Supplement to H-58-09-MIM-006
Approved Change to TM 1-1520-248-23 Requiring NDI of Tail Rotor Gearbox Support

DA Form 2028 DCN 09A01762, Web Reference Number 090430120

Make the following Changes to TM 1-1520-266-23

TAIL ROTOR GEARBOX SUPPORT ASSEMBLY (OH-58D) (ET).

Figure 1. Tail Rotor Gearbox Support Area

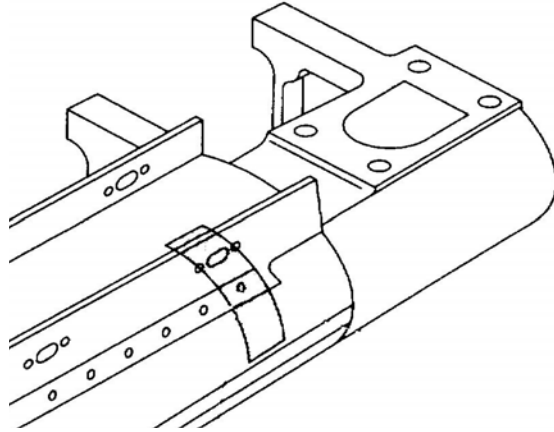
4.9.2 Defects: Cracks may occur at various locations throughout the Tail Rotor Gearbox Support Structure, pay particular attention to the mounting holes and guide pin holes. No cracks are allowed.

4.9.3.3 Access. Remove the tail rotor gearbox and support assembly access door to allow inspection of the interior part of the assembly IAW applicable manuals listed in TM 1-1520-266-23 Table 1-1.

Figure 2A

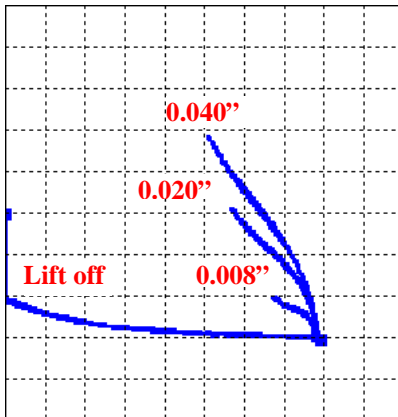
1. Place the probe on a bare section of the test block and press NULL.
2. Utilize the ANGLE function to achieve horizontal lift-off. Reference Figure 2A.
3. Set up a 5 division vertical response from the 0.040” EDM notch on test block.
4. Place a .002" non-conductive shim over the 0.040” EDM on the test block and slide the probe over the notch.
5. Repeat step 4 utilizing a .005" and a .010" shim. Reference Figure 2B.
6. Place the probe on the material to be tested, note the horizontal deflection. Reference Figure 2C.
7. Lift-off may be slightly different due to the conductivity differences between the test block and the material being tested.
8. Non-conductive coatings less than .003" do not require lift-off compensation. If the coating is greater than .003" utilize the appropriate non-conductive shim during set up below.

1. Determine non-conductive coating thickness on the test material IAW paragraph 9 b.
2. Null the probe on the test block with the appropriate thickness of non-conductive shim between the probe and the reference standard. The shim should be large enough to cover all three EDM notches.
3. Adjust phase as required to obtain horizontal lift-off.
4. Move probe over all three notches in test block. Adjust gain to obtain a five block vertical signal when probe is passed over 0.040 inch notch in test block. Figure 2A.

Figure 3

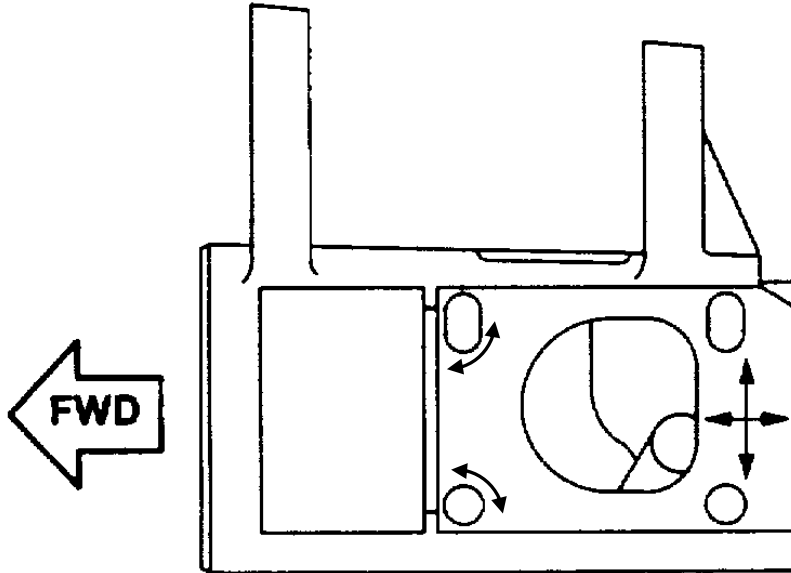
Pay particular attention around the holes. These areas are susceptible to cracking at the hole and propagating outward. (Refer to Figure 3)
